**Re: Comments of Pyramid Lake Paiute Tribe re Item 23 of Nov. 10, 2020 Agenda,
Appeal of Denial of SUP No. WSUP20-0013 for Orni 36, LLC**

RE: **Comments on the Draft Environmental Assessment and the Hydrogeologic Evaluation for the North Valley Geothermal Development Project at the San Emidio Geothermal Field**

Comments on the Environmental Assessment (EA) and Hydrogeologic Evaluation for the North Valley Geothermal Development Project at the San Emidio Geothermal Field (Reports dated May 2020)

Figure A-1. Project Area

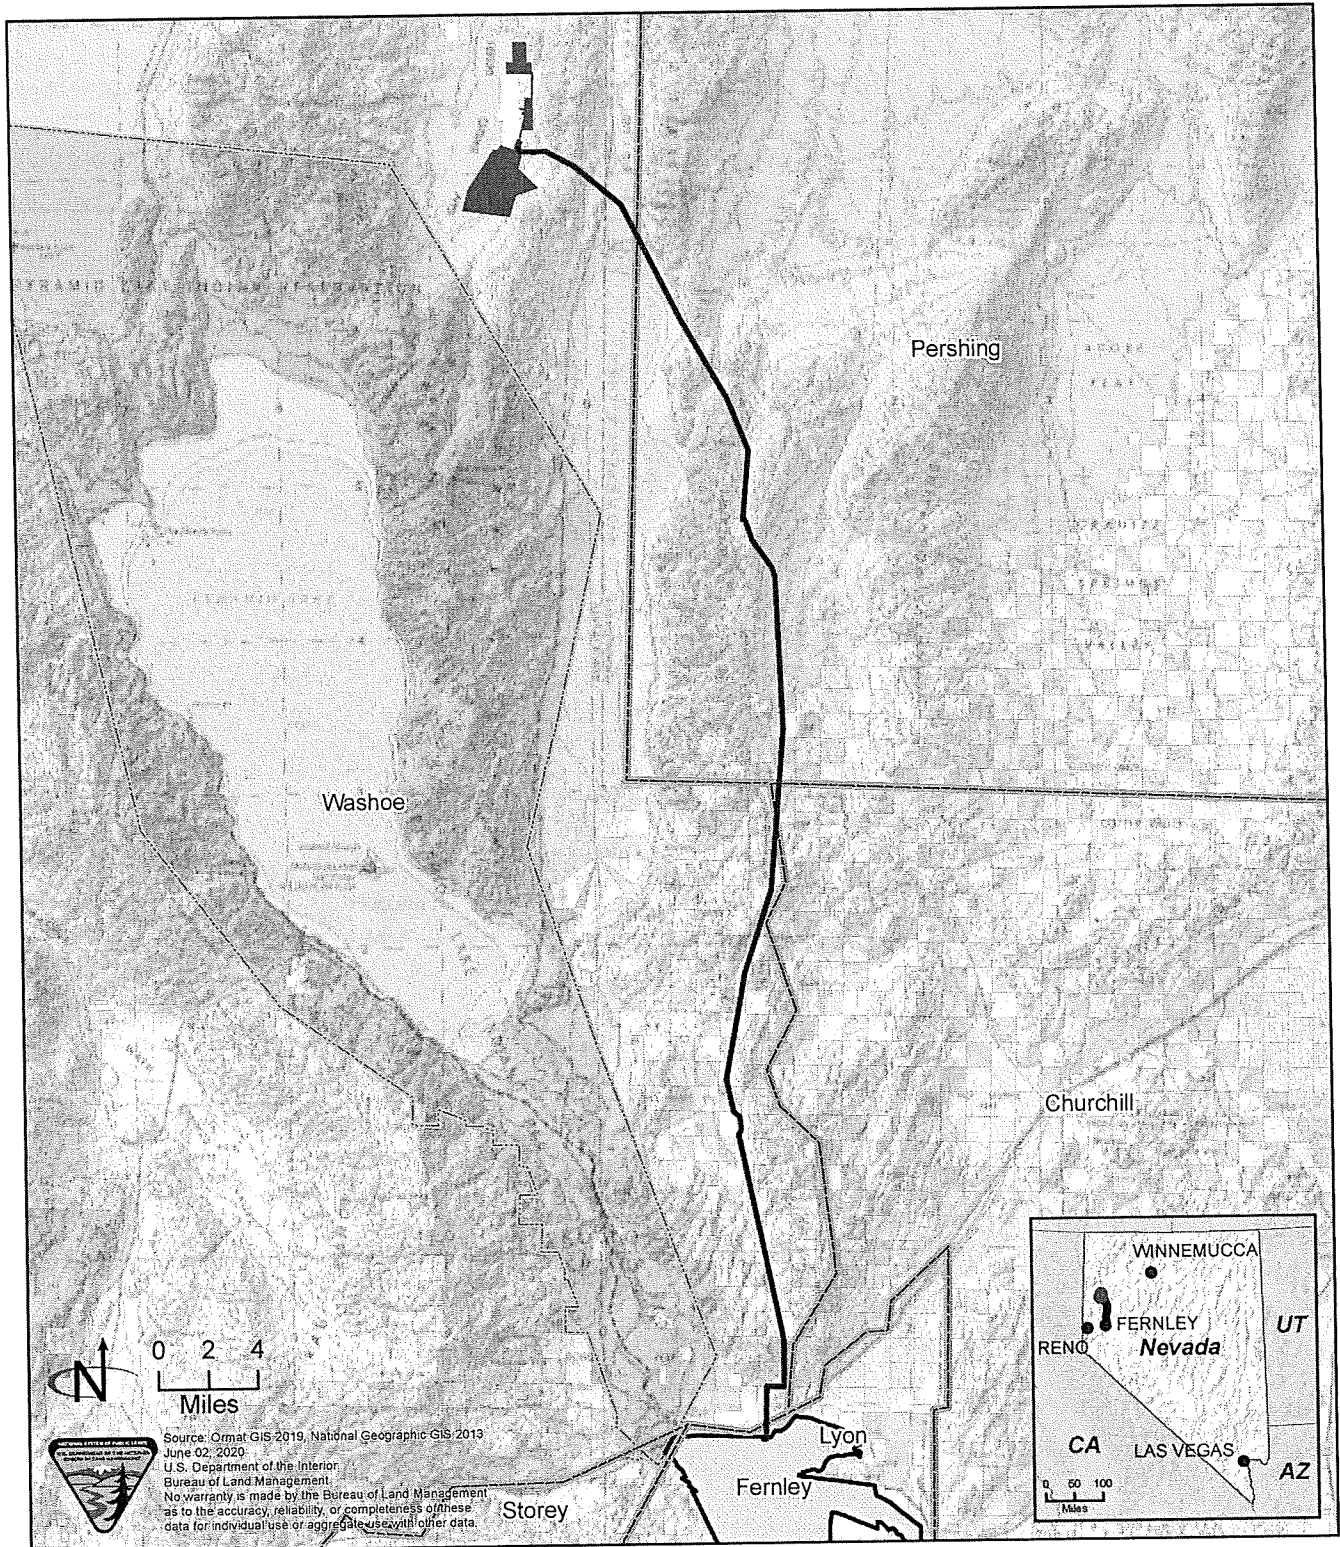
The Tribe provided extensive comments regarding the Proposed Project to the Washoe County Planning Commission in advance of its consideration of the SUP. In summary, the Tribe's concerns stem from the close proximity of the Proposed Project to the Pyramid Lake Paiute Reservation (Reservation). As shown in Figure A-1 of the Draft EA (provided with these

comments), the Proposed Project is located approximately 3 miles to the northeast of the Reservation boundary, which makes the reservation a neighboring and/or adjacent property. Because the Proposed Project, if approved, will withdraw large volumes of groundwater from the San Emidio Basin, which basin extends into the Reservation boundary, the Proposed Project will adversely impact Tribal resources. First, the Tribe has serious concern with the Proposed Project's high potential to impact the Tribe's federal reserved groundwater rights within the Reservation boundary, including geothermal and underground water. The impacts to the Tribe's groundwater resources are not just to the volume of water taken from the Tribe's portion of the basin, but also to the quality of the groundwater. These impacts would amount to the loss of an irretrievable resource to the Reservation and the Tribe.

FIGURE 1

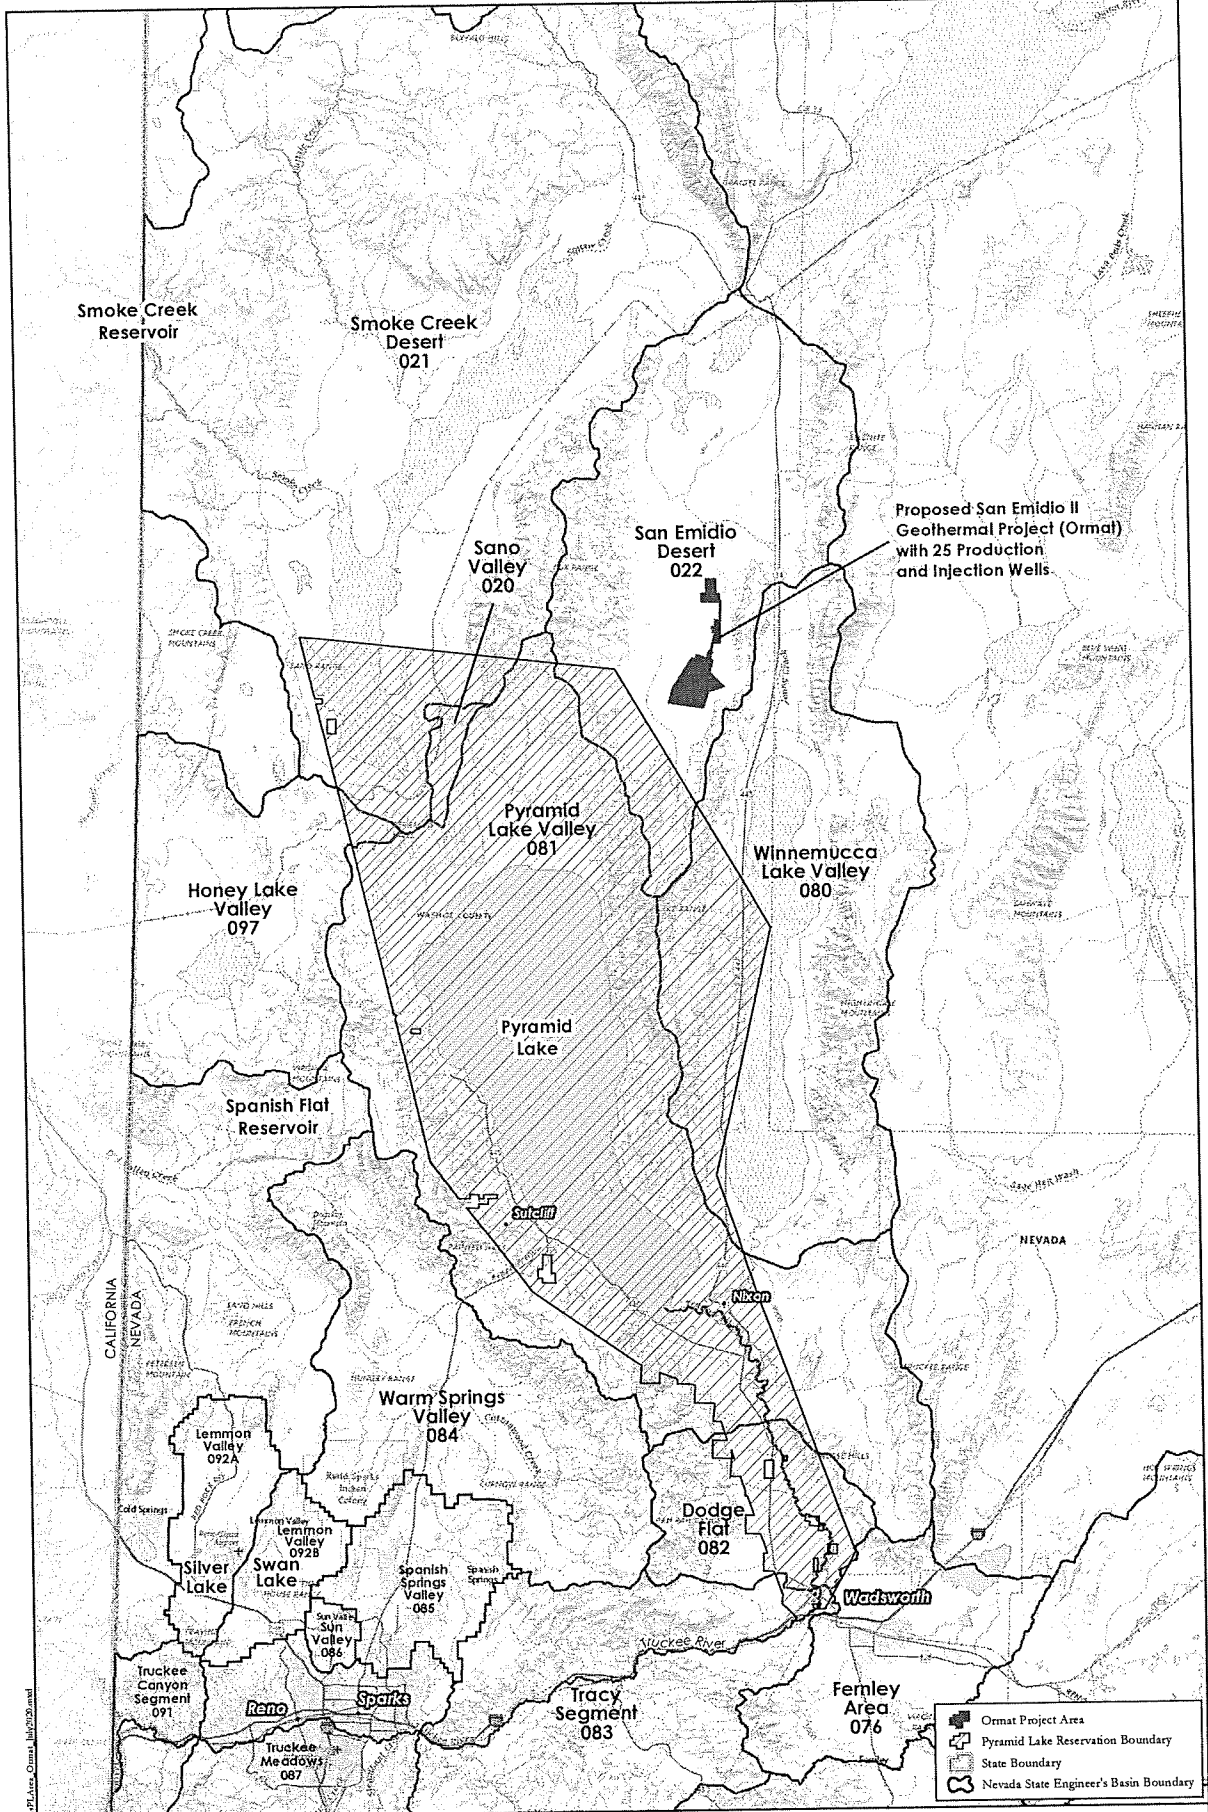
The proposed Project is located in the San Emidio Desert Basin, less than two (2) miles from the northeastern boundary of the Pyramid Lake Reservation. The San Emidio Desert Basin is identified by the Nevada State Engineer's Office as Hydrographic Basin No. 22. The location of the Project relative to the Pyramid Lake Reservation, and within the San Emidio Desert Basin No. 22, is shown on **Figure 1** attached to this Technical Memorandum.

FIGURE 2

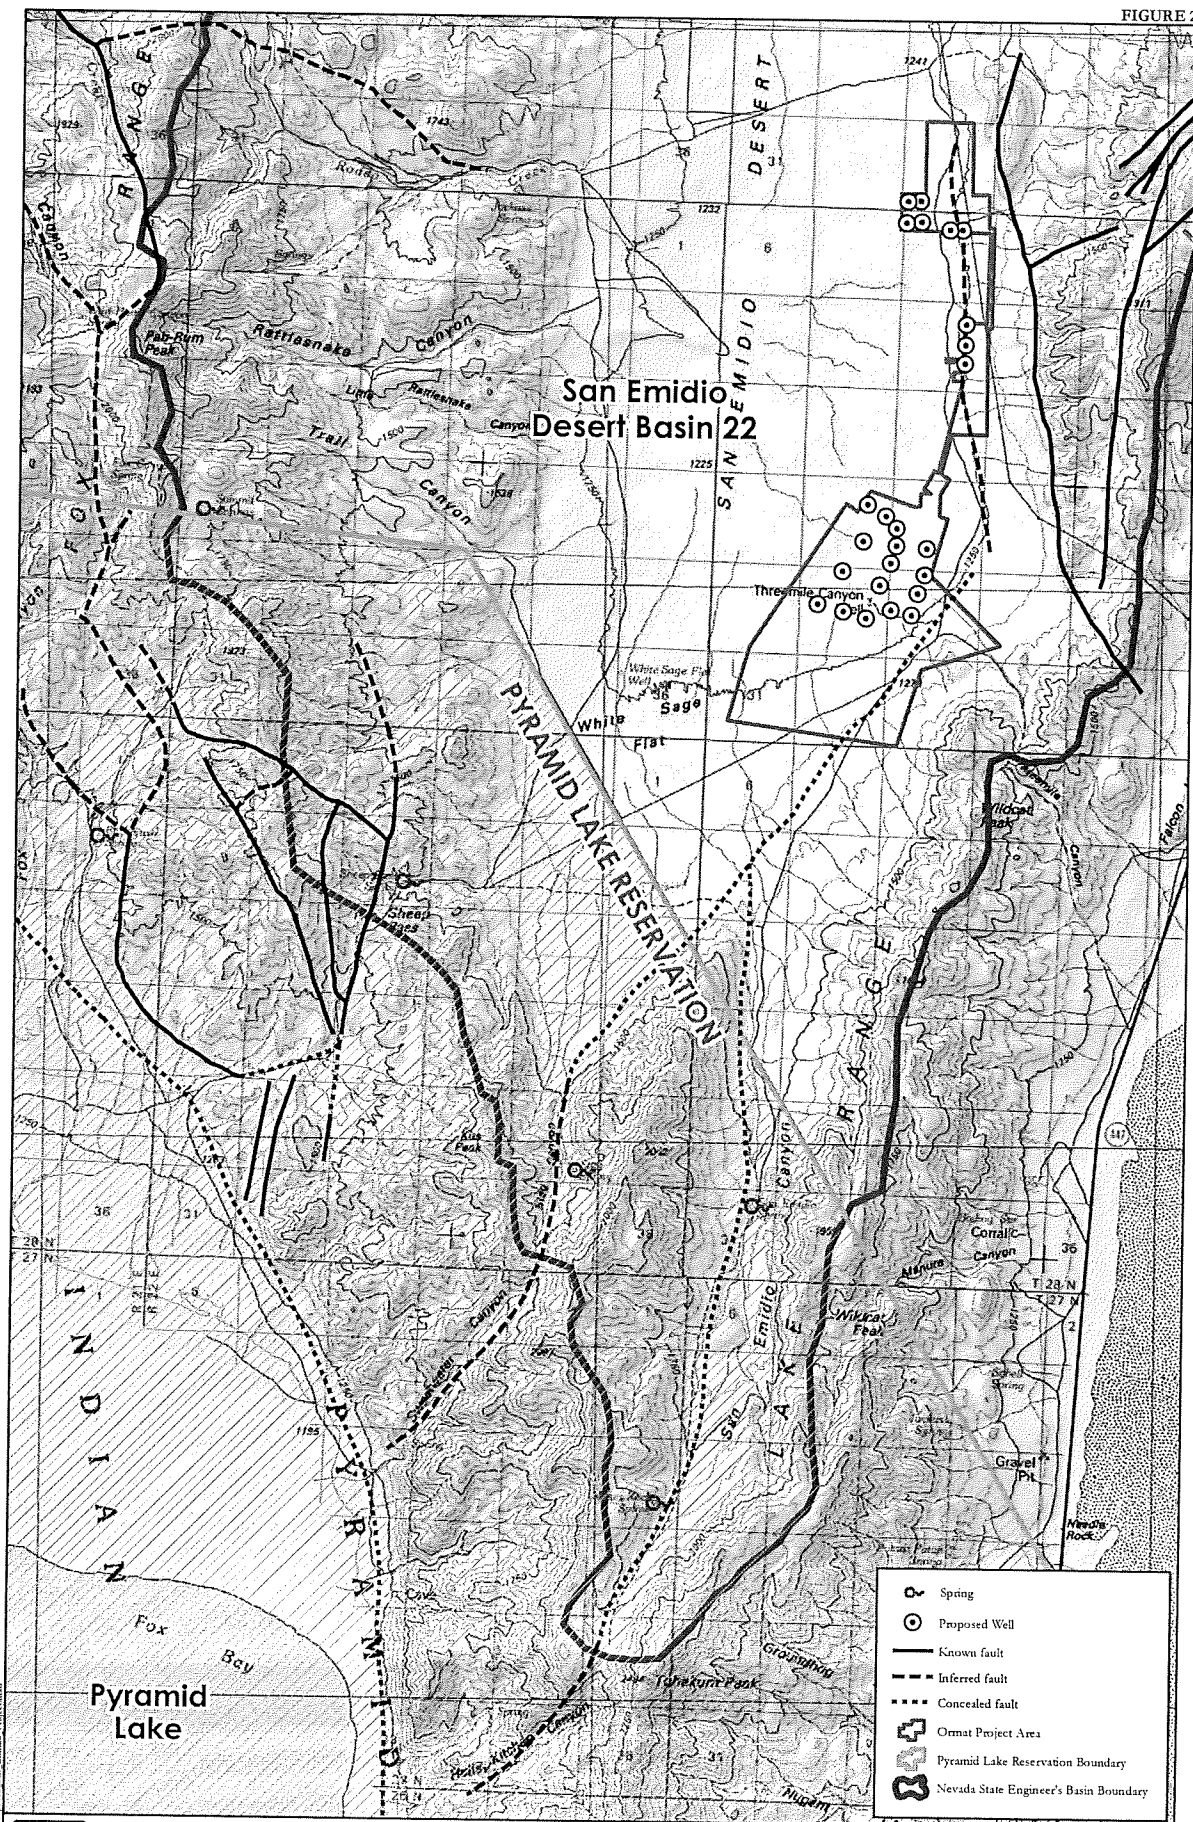
The EA does not provide a map showing the fault systems in the vicinity of the proposed Project. Figure 3 of the Hydro Report does show the location of some faults in relation to the proposed Project, including references to Lake Range, San Emidio, and Empire Faults. As generally illustrated on Figure 3 of the Hydro Report, the Lake Range fault extends from the Pyramid Lake into the San Emidio Desert Basin and the proposed Project area. However, Figure 3 of the Hydro Report does not correctly represent the full extent of the fault identified as the San Emidio Fault.

The full extent of the faults extending from the Pyramid Lake into the San Emidio Desert Basin are provided on Figure 2 attached to this Technical Memorandum (faults in Figure 2 are based on USGS, 2007). As shown on the attached Figure 2, there are two faults that extend from the Pyramid Lake into the San Emidio Desert Basin. The southernmost fault extends from the Pyramid Lake through the San Emidio Canyon and a second fault to the north extends from the Pyramid Lake through the Sweetwater Canyon/Stag Canyon. Both faults extend from Pyramid Lake into the San Emidio Desert and the geothermal production area associated with the proposed Project. Figure 3 in the Hydro Report should be corrected to accurately show both faults extending from the Pyramid Lake into San Emidio Desert Basin.

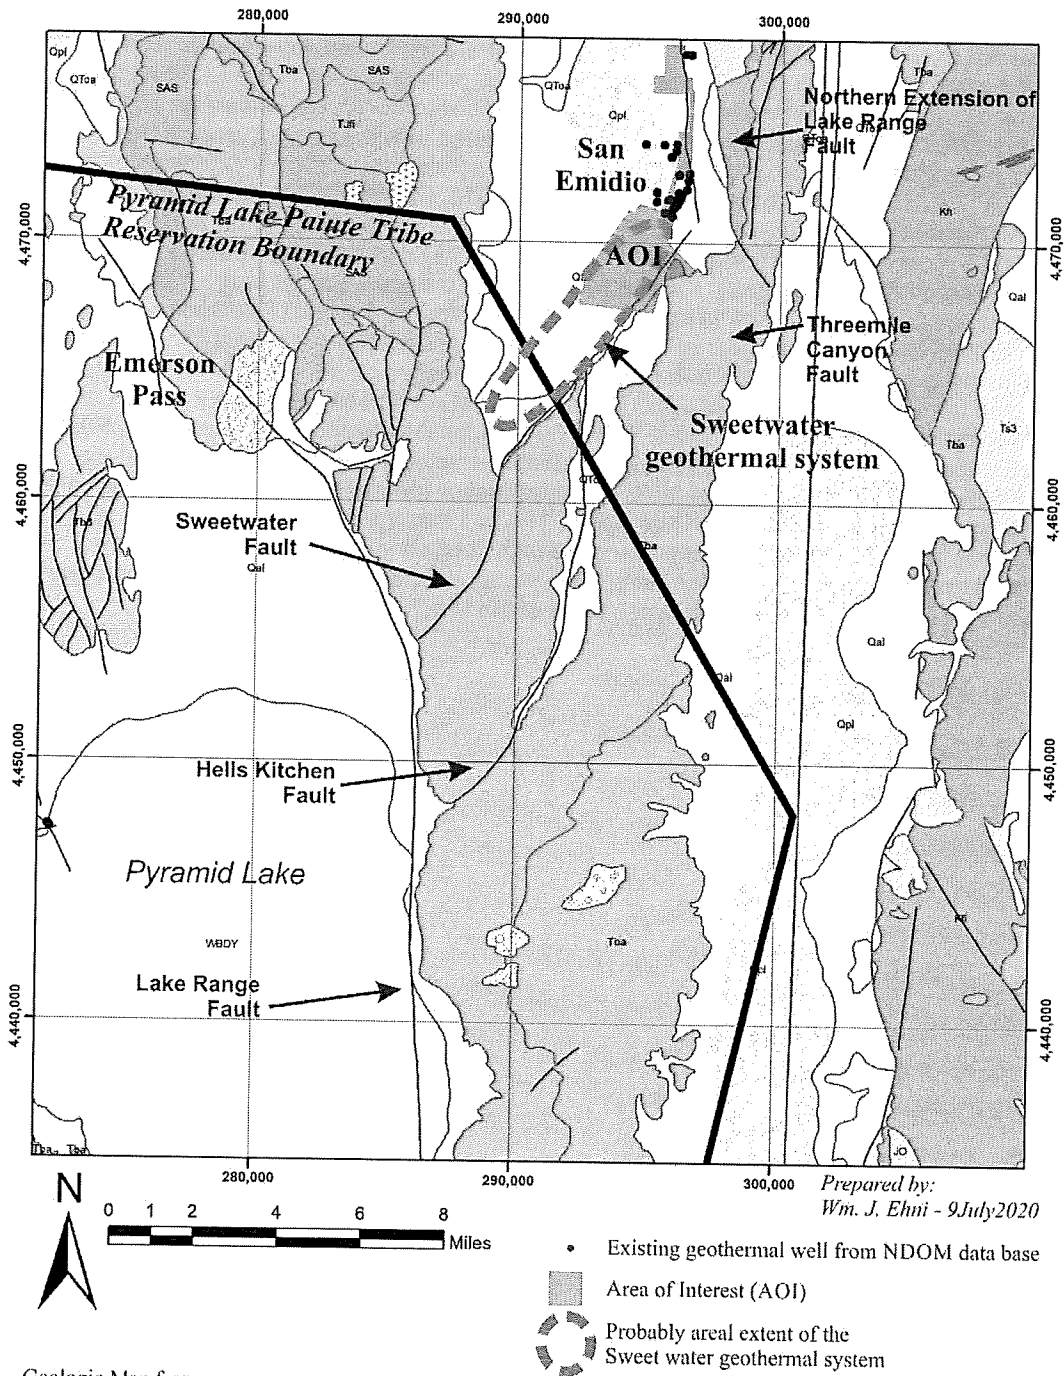
The EA discusses the link between faults and geothermal systems however fails to present maps that show the location of these faults. The supporting documents of the EA and Hydrogeologic Evaluation indicate that the geothermal system at San Emidio extends to the southwest as noted by Warren (2018) where he states "drilling south of the producing field discovered a new, hotter (>160C) resource that is

currently in the early development stages” and this area coincided with the Sweetwater fault that extends onto the PLPT Reservation (see Figure 1 by Wm. J. Ehni). Geologic mapping clearly links the Lake Range Fault on the east side of Pyramid Lake with the production faults at the San Emidio geothermal project (Crafford 2007, Faulds et al 2013, Anderson and Faulds 2013, Moore 1979) as indicated on the attached map by Ehni (Figure 1). San Emidio geothermal production wells are located adjacent to the north end of the Lake Range (Mackelprang and More 1979) which extends south where the Lake Range forms the eastern side of Pyramid Lake. The fault system associated with the San Emidio geothermal system is the northern extension of accommodation faults related to the Lake Range Fault. The Lake Range Fault is a right lateral, right stepping west dipping normal fault. The producing faults at San Emidio are a northern extension of this fault. The Lake Range Fault splays off to the north on the Sweetwater and Hell’s Kitchen faults which are most likely extensional accommodation (tensional) faults and are probably the primary fault system that is being produced at the San Emidio geothermal project.

The report emphasizes that the geothermal system is fault controlled but then states that "These north-northeast striking structures appear to be geologically independent of the Lake Range, Fox Range, and Pyramid Lake faults, which appear south of the Project area". There are no temperature gradient or isotherm maps in the hydrogeologic evaluation that support this conclusion. Folsom (2020, Figure 1) presents an isotherm map at 30m below ground level; however, as Warren(2018) points out, the San Emidio geothermal resource is hotter to the south (towards the PLPT reservation) and the anomaly is open-ended to the south. In Figure 1 of the attached map Ehni outlines the areal extent of the hypothetical "Sweetwater geothermal system". The proposed North Valley Geothermal Development project is on the northeast end of the Sweetwater geothermal system. The right stepping right lateral Lake Range fault on the shores of the Pyramid Lake, and the Northern Extension of the Lake Range Fault adjacent to the existing San Emidio project, are connected by the dilational Sweetwater and Hell's Kitchen faults. The hydrogeologic evaluation completely misses this correlation. The San Emidio geothermal resource is located on the north end of the dilational Sweetwater extensional (NW-SE tension) fault zone which connects the northern extension of the Lake Range Fault in the San Emidio

basin with the Lake Range fault in the Pyramid Lake basin. As pointed out by Warren (2018), the San Emidio geothermal anomaly extends to the south, which is where the Sweetwater fault is located. The hydrogeologic evaluation failed to show the relationship of the hottest portion of the San Emidio geothermal system and the Sweetwater fault. On Page 2-2 the Hydrogeologic Evaluation states that "The San Emidio and Empire faults are in and most closely associated with the Project" and as depicted on the Figure 3 of the Hydrogeologic Evaluation, the Empire fault is actually the northern extension of the Sweetwater fault (Faulds et al 2013, Anderson and Faulds 2013, Crafford 2007). It should be noted that The Faulting on Figure 3 of the Hydrogeologic Evaluation is not consistent with other published maps (Faulds et al 2013, Anderson and Faulds 2013, Crafford 2007). The Lake Range Fault on Figure 3 splits at Hells Kitchen and on figure 3 the Hells Kitchen fault is called the Lake Range fault. If this is correct, then the Lake Range fault that appears to supply the hot water for the Pyramid Hot Springs is the same fault that San Emidio is on. On Page 4-6 of the Hydrogeologic Evaluation states that "The Lake Range fault extends from the southeastern shore of Pyramid Lake, branches off into an east-northeast-striking oblique fault, and terminates southeast of Wind Mountain Mine" which basically says that the Lake Range fault connects Pyramid Lake with San Emidio. However, it is most likely that the Lake Range Fault and the Northern Extension of the Lake Range Fault are components of a "right stepping, right lateral" fault system and the Sweetwater-Hell's Kitchen faults are dilational or transitional pull apart geothermal zones as noted on figure 6 of the Hydrogeologic Evaluation. The fact that there are no maps of the fault system in the EA, and that the fault system is poorly described with conflicting statements, supports the recommendation that the proposed development, if approved, will need a robust monitoring program, directed by the PLPT, in order to protect the resources of the PLPT.
